ADDENDUM NO. 4

Date: September 25, 2023

Project Name: Traffic Operations Facility, IRC-2104

Bid Number: **2023059**

FLOOR PLAN

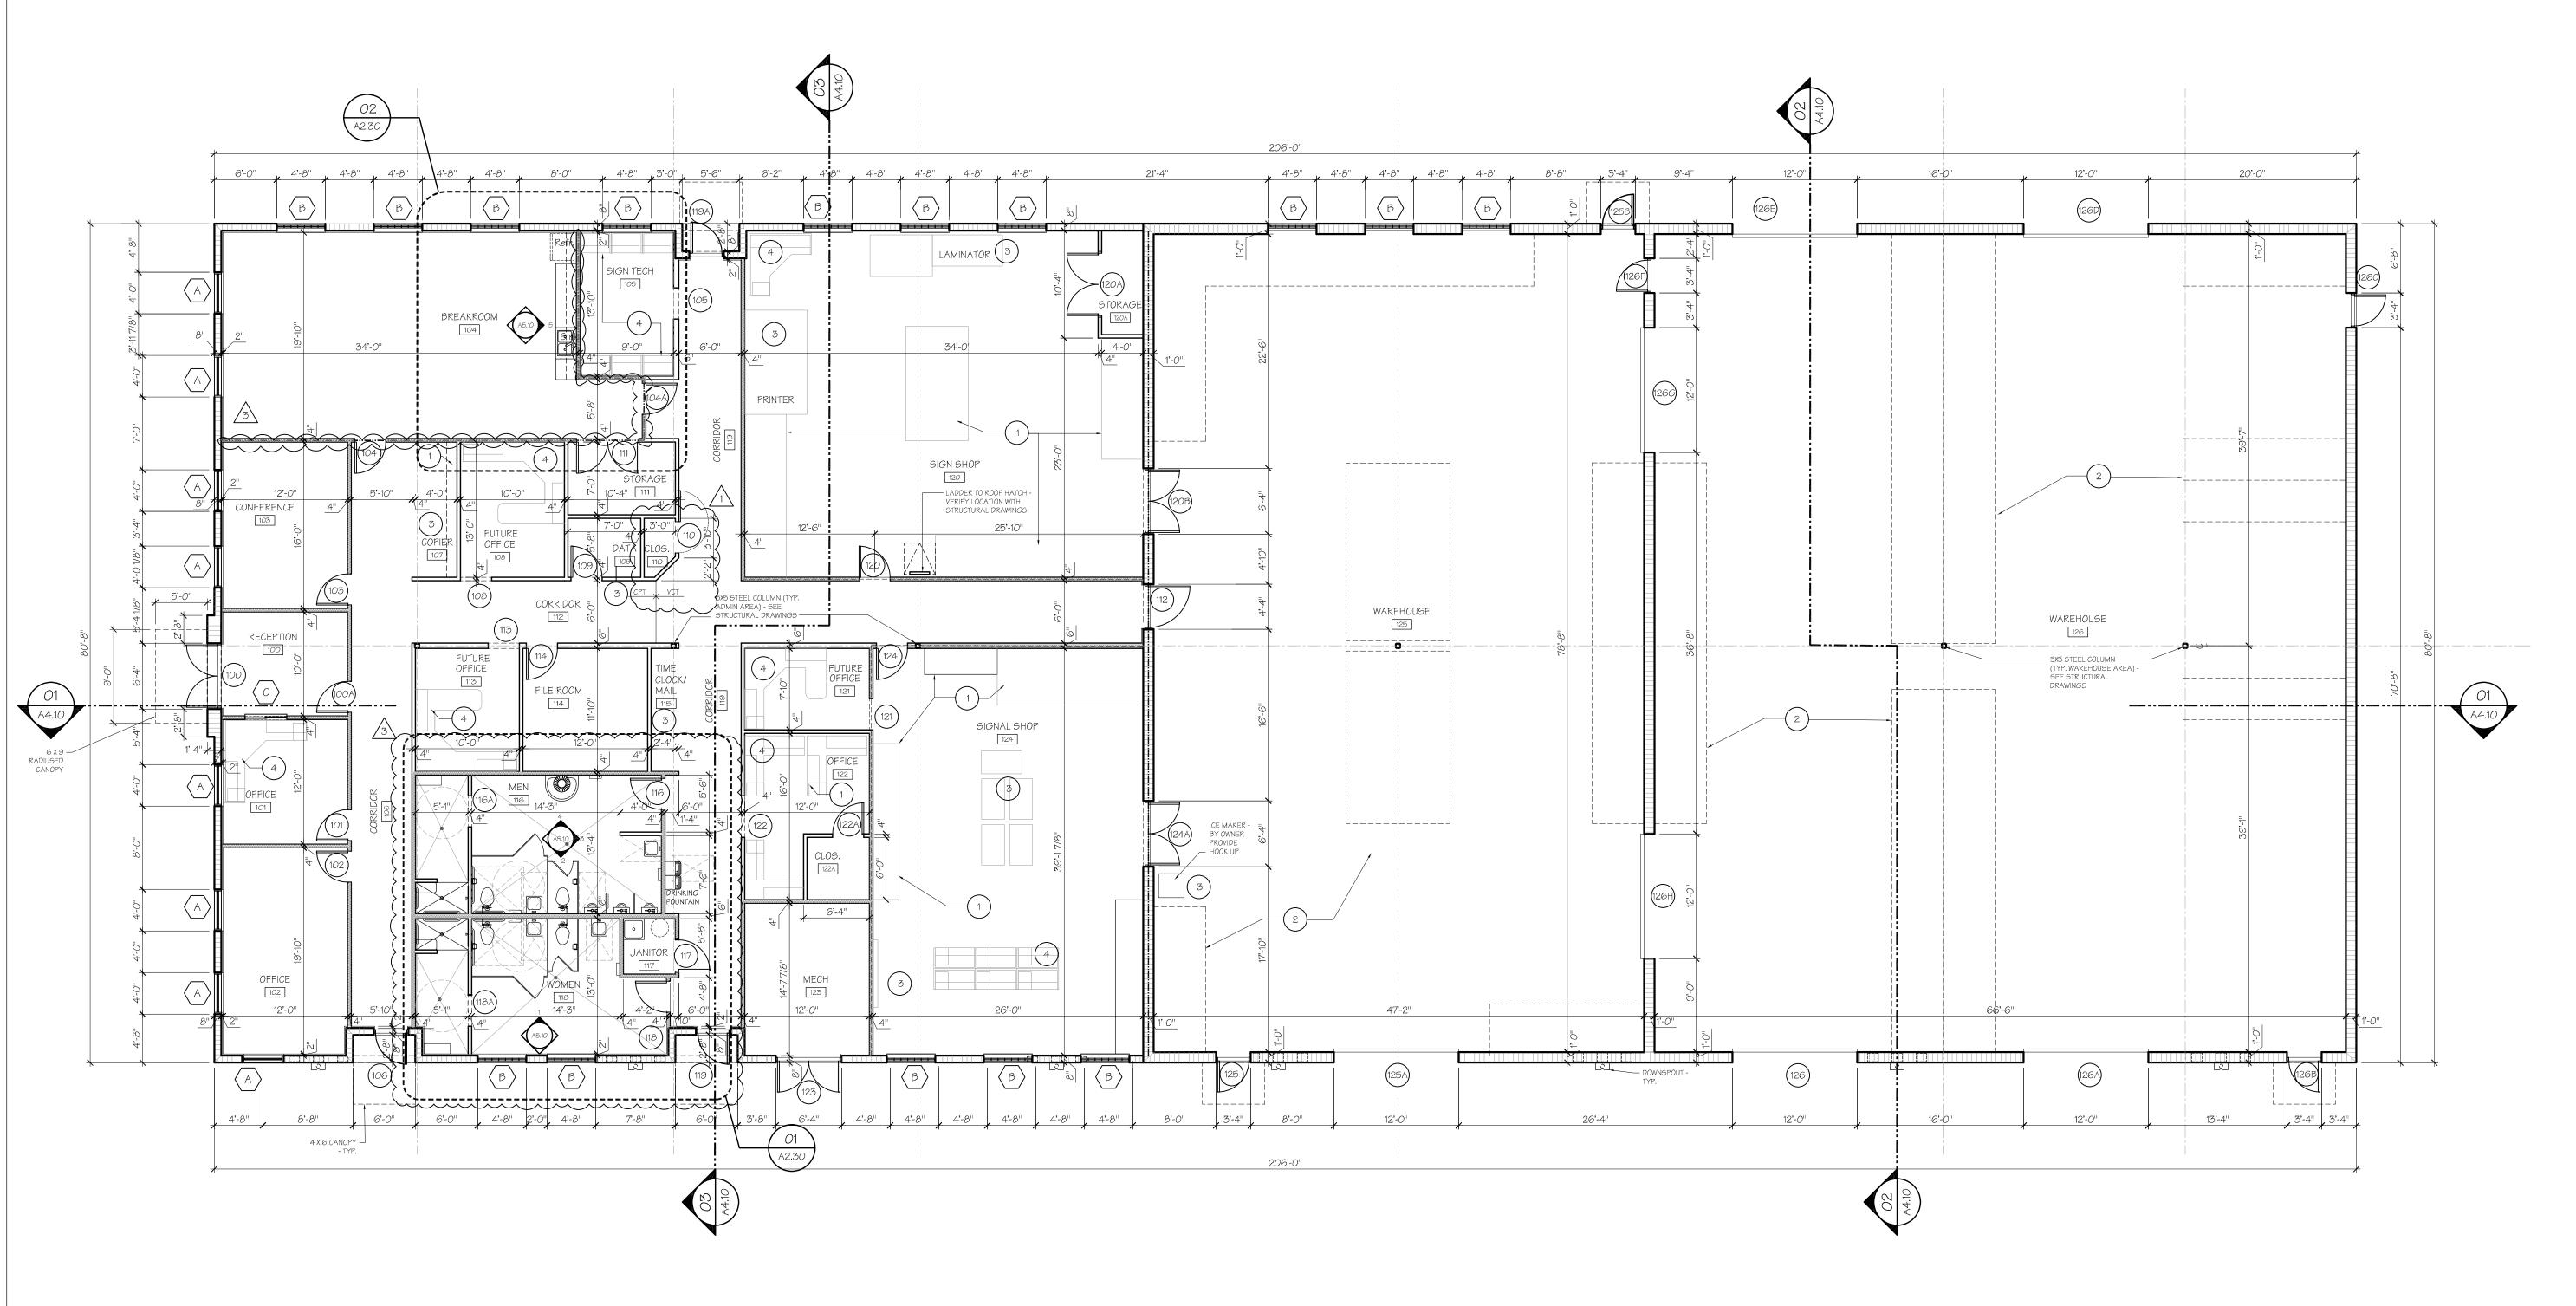
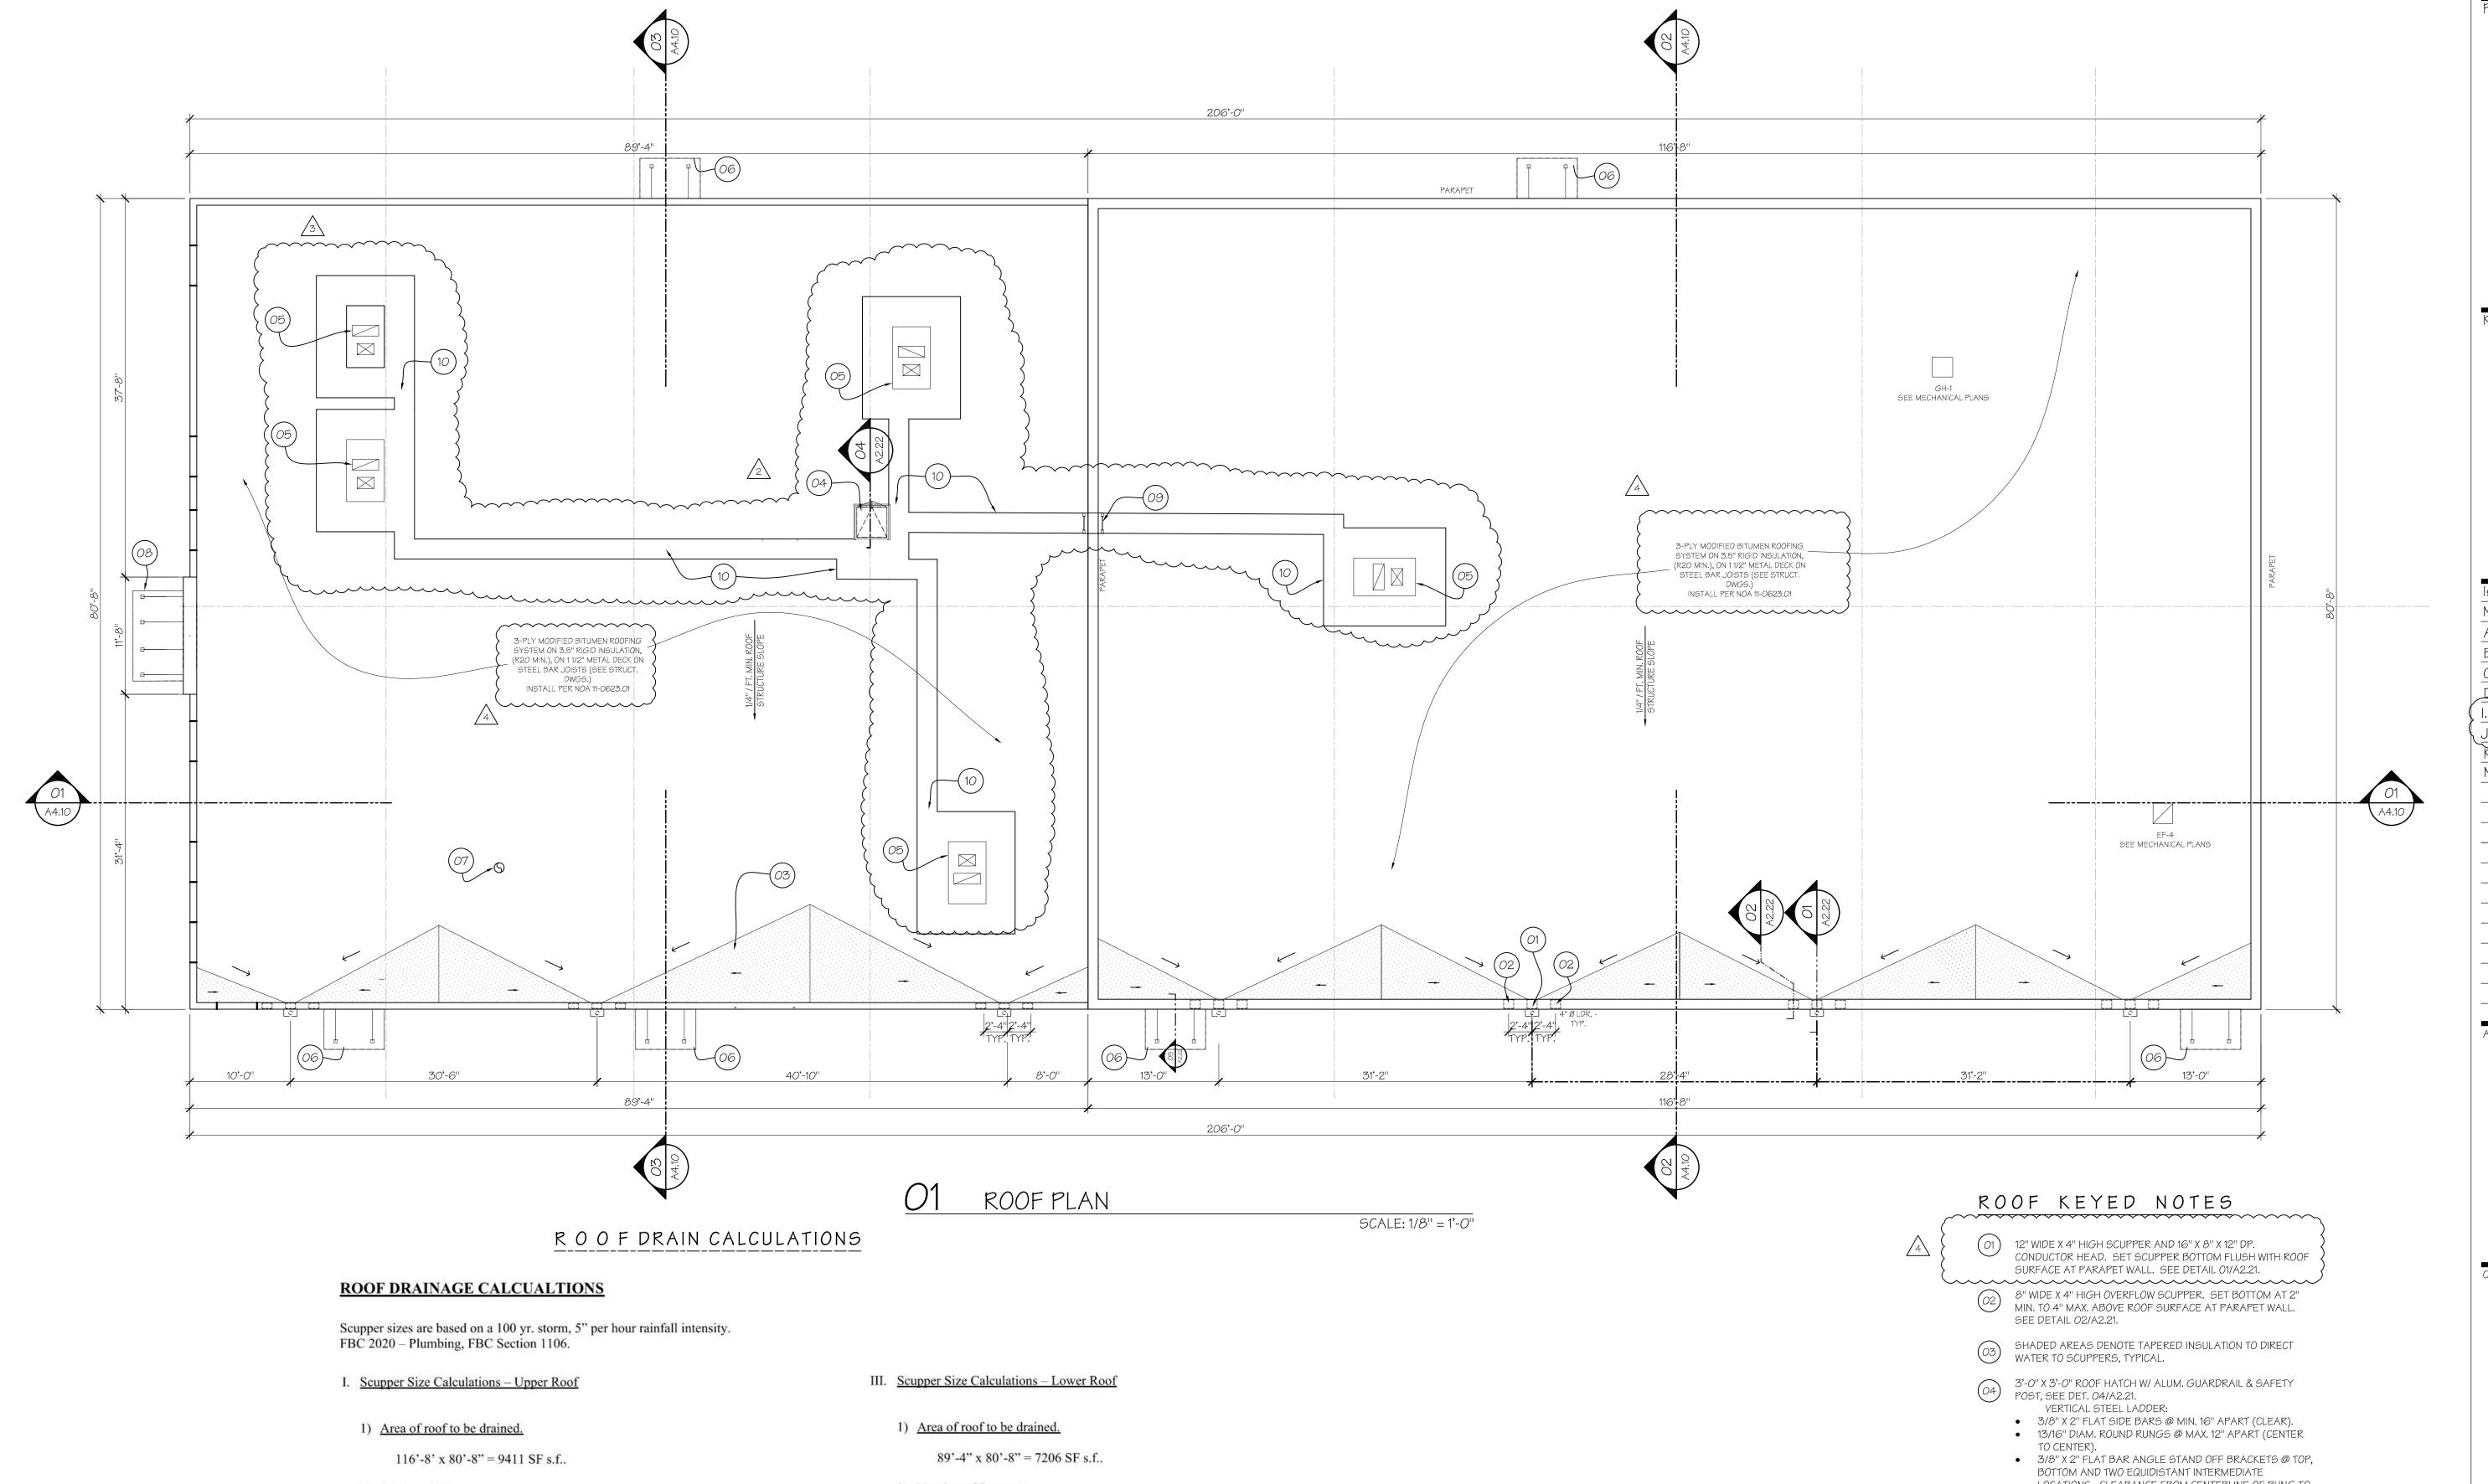
- Answer 41. Flashing is only required at sill locations as indicated on Detail 02 on Sheet A6.22.
- Question 42. Drawing A2.10 Construction Legend includes a one-hour assembly wall. Floor plans do not show any one-hour assemblies. Please confirm this is not applicable to project.

- Answer 42. Drawing A2.10 Construction Legend has been Revised. 1 Hour Rated Assembly is not applicable.
- Question 43. Please confirm there is no stucco on masonry walls at Warehouse 125 and 126 as shown on A2.10. Please confirm there is no stucco nor furring and drywall on masonry walls at Sign Shop 120 and Signal Shop124 as shown on A2.10.
